**PSE&G** Public Service  
Electric and Gas  
Company

August 20, 1984

HOPE CREEK GENERATING STATION  
DOCKET NO. 50-354  
DRAFT SAFETY EVALUATION REPORT  
OPEN ITEM STATUS

Attachment 1 is a current list which provides a status of the open items identified in Section 1.7 of the Draft Safety Evaluation Report (SER). Items identified as "complete" are those for which PSE&G has provided responses and no confirmation of status has been received from the staff. We will consider these items closed unless notified otherwise. In order to permit timely resolution of items identified as "complete" which may not be resolved to the staff's satisfaction, please provide a specific description of the issue which remains to be resolved.

**FIGURE 220.21-21**  
**RESPONSE SPECTRA COMPARISON,**  
**AUXILIARY BUILDING AT ELEV. 178'-0",**  
**N-S, SSE, 2% DAMPING**

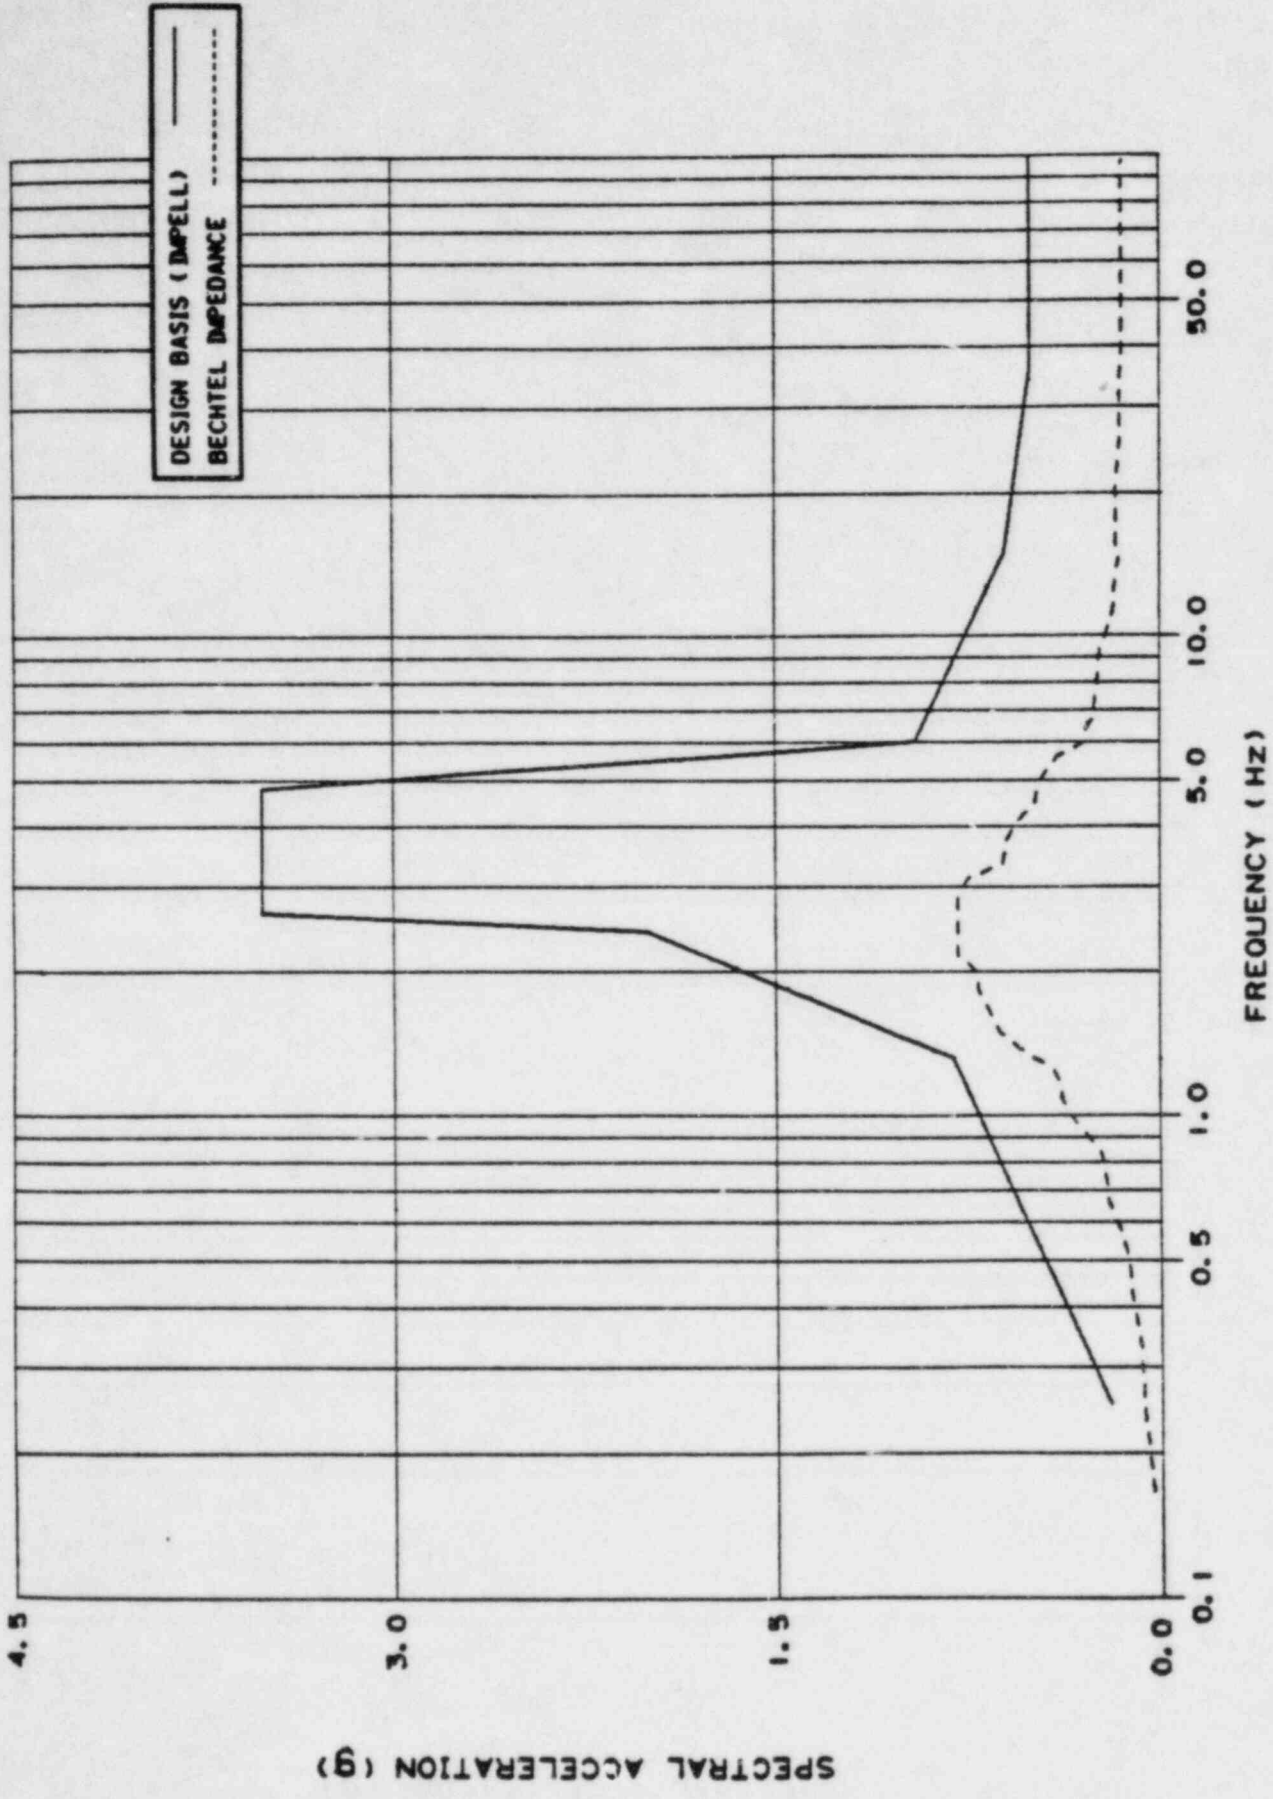
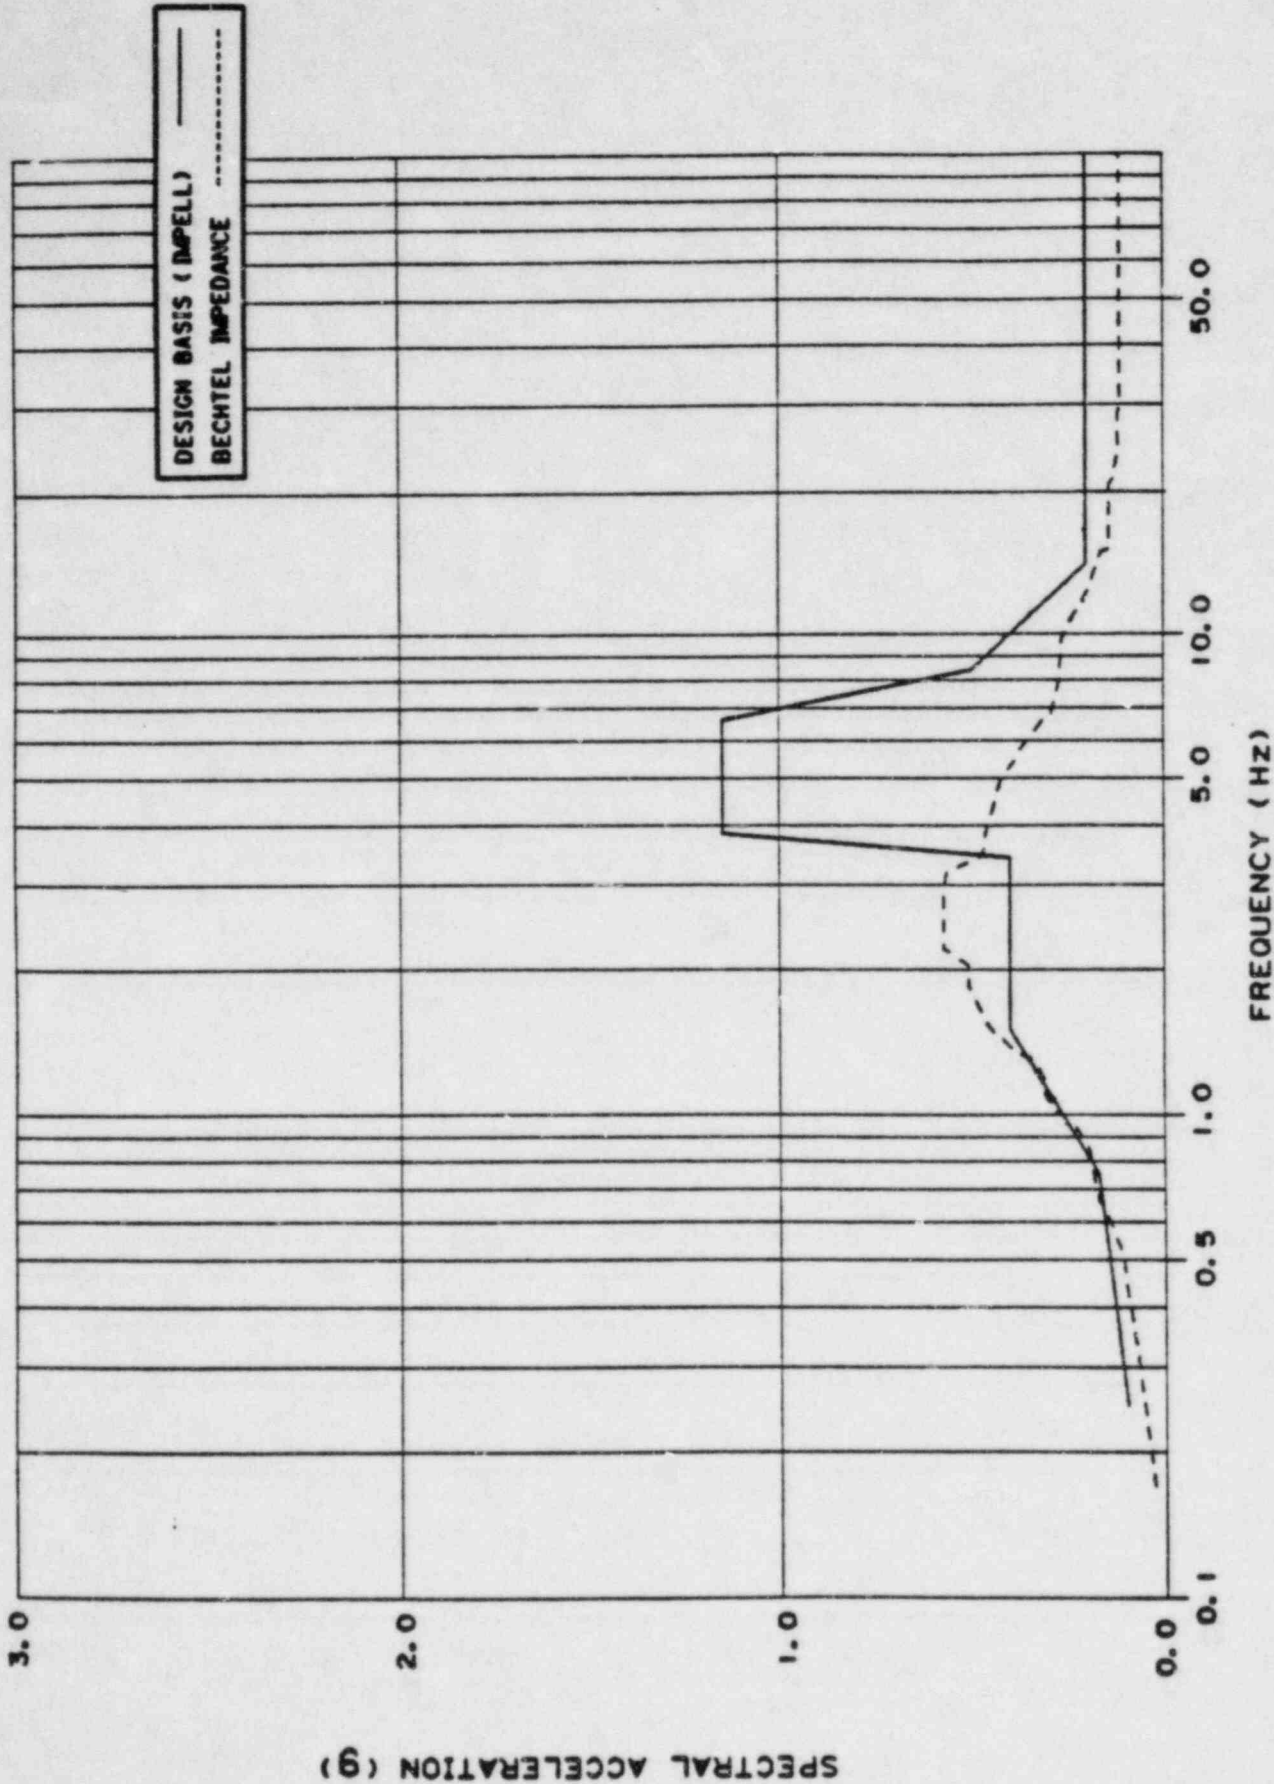
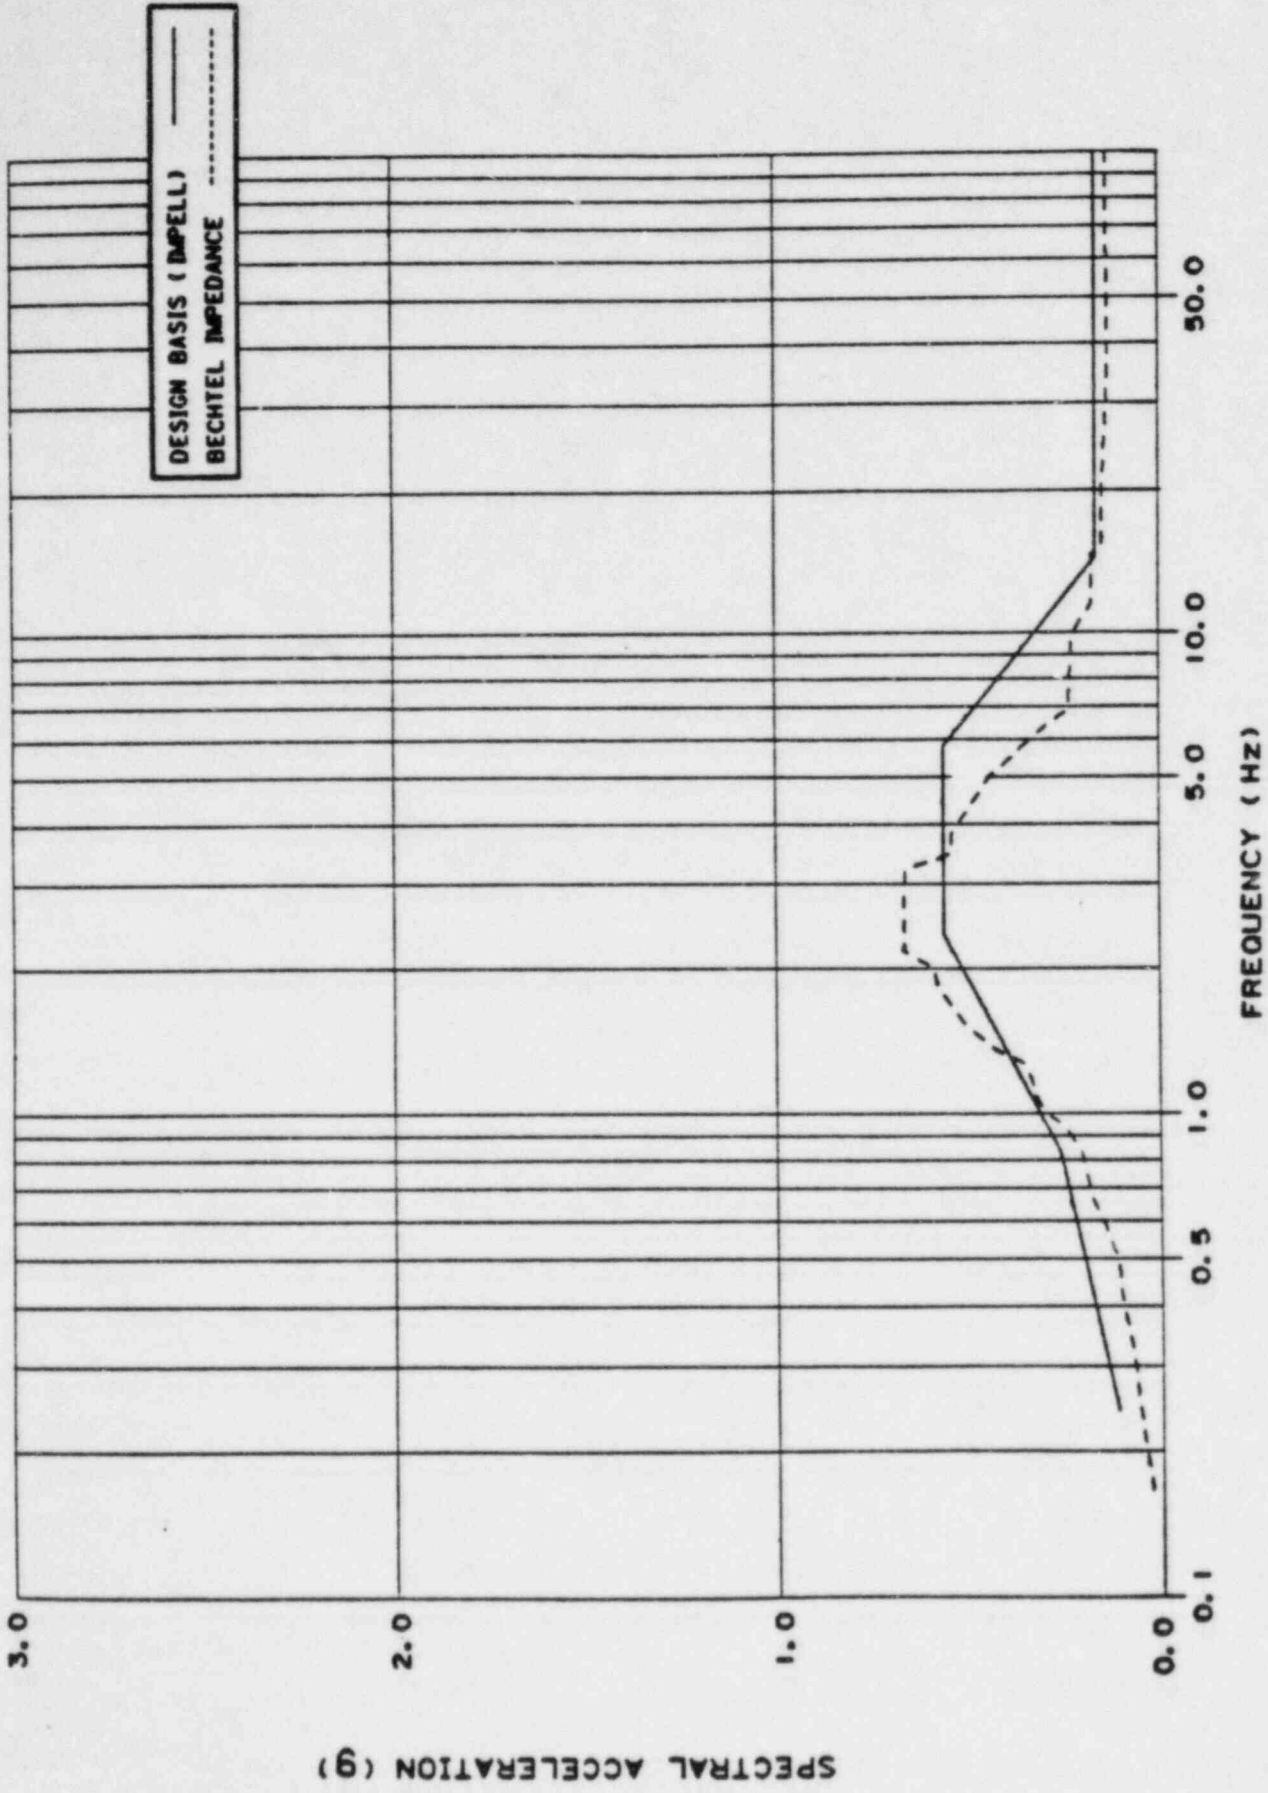
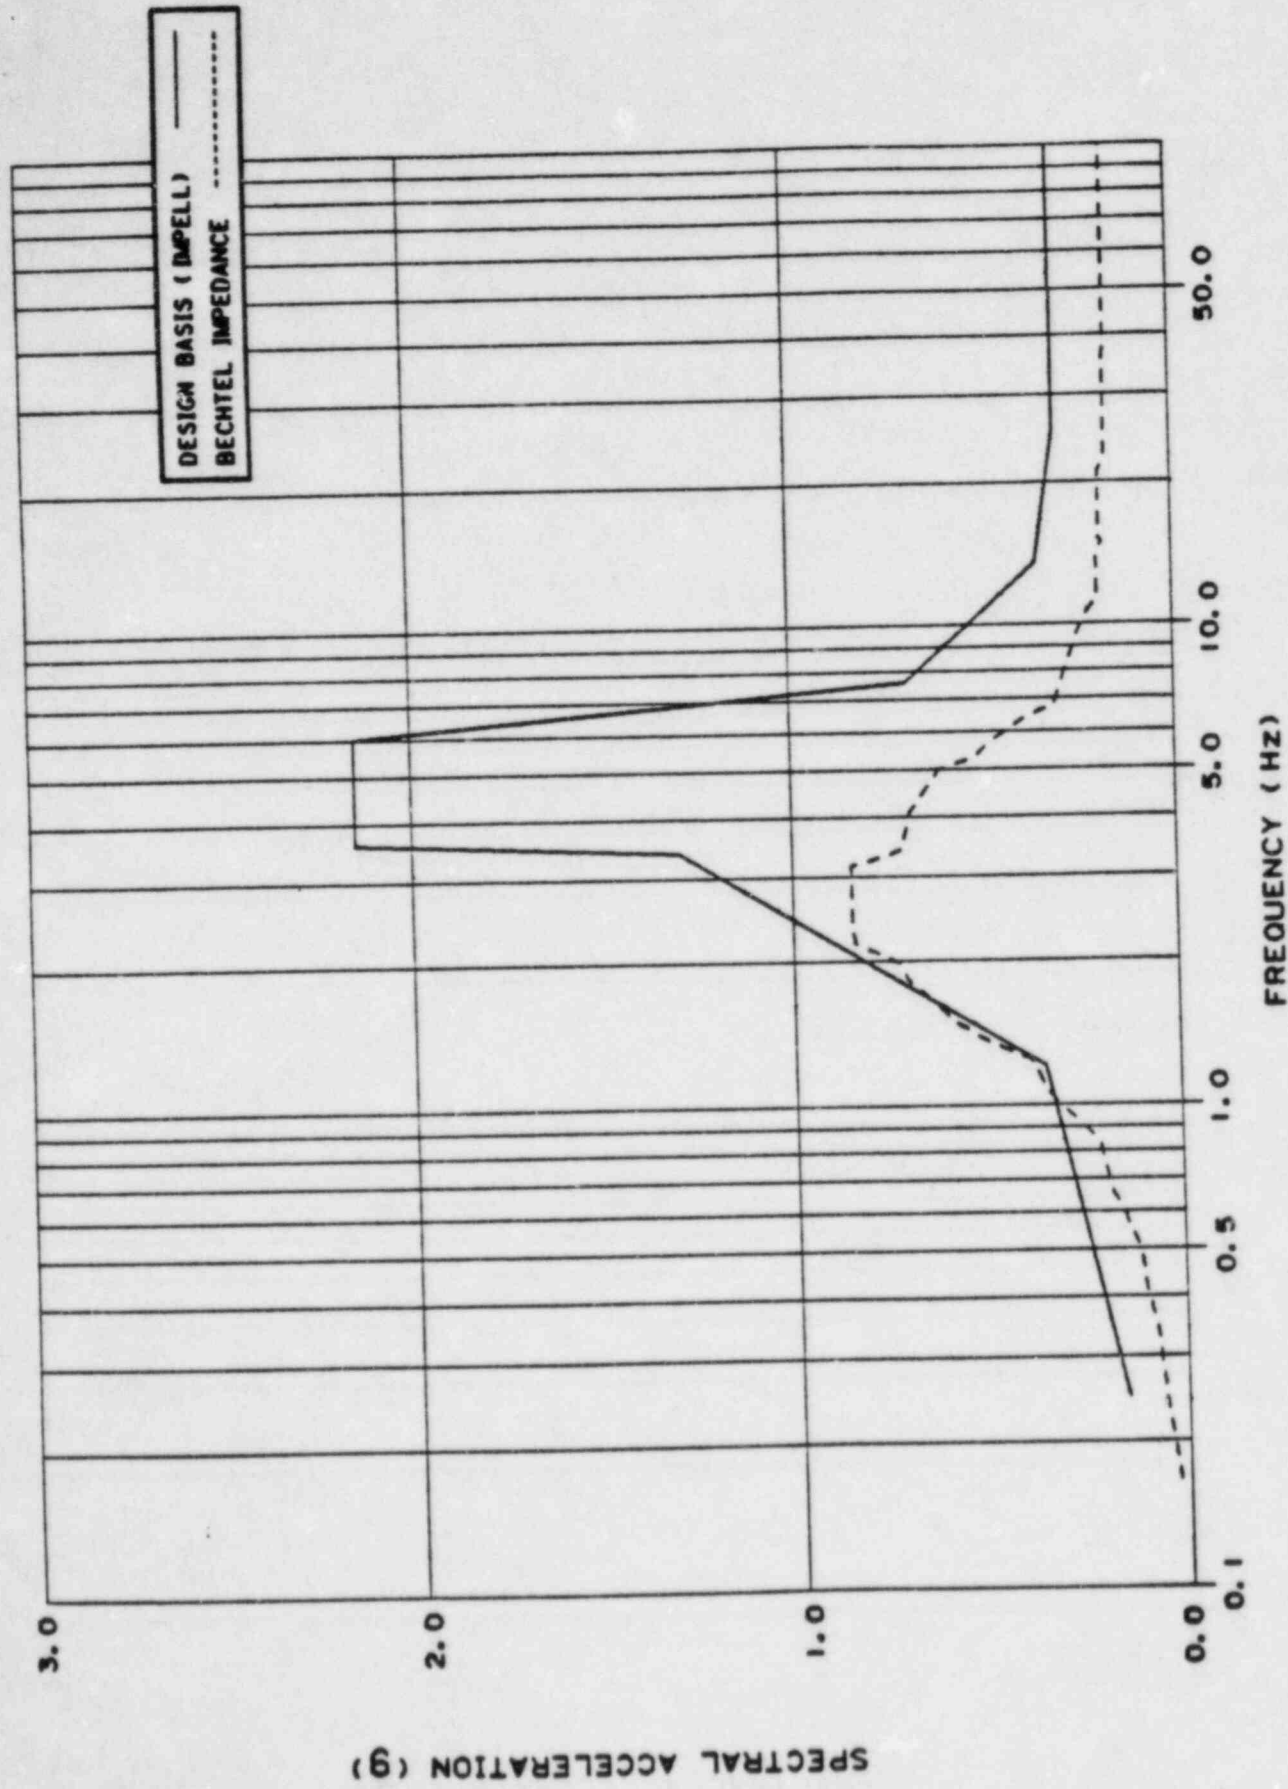
Figures 220.21-1 through 220.21-54 show a comparison of the 2 percent damping response spectra obtained from the design basis finite element and the impedance analyses for the reactor building, auxiliary building and the service water intake structure (SWIS).

¶ For the reactor and auxiliary buildings, the peak spectral accelerations obtained from the impedance analysis are generally lower than those obtained from the design basis analysis. However, the impedance analysis response spectra are not completely enveloped by those obtained from the design basis analysis, especially in the frequency range from 1.0 to 3.5 Hz. Also, there are some local exceedances in the higher frequency range, as shown in Figures 220.21-1 through 220.21-36. ¶ For the SWIS (Figures 220.21-37 through 220.21-54), the impedance analysis response spectra are generally enveloped by those obtained from the design basis analysis at elevation 114.0 feet. For other elevations, the impedance analysis spectral accelerations exceed the design basis spectral accelerations in some frequency ranges. These ranges vary approximately between 1.5 and 10.0 Hz.

In all cases, the items reviewed during these sampling studies can accommodate the loads resulting from the impedance analysis. Therefore, the impedance analysis results have no impact on the plant design.
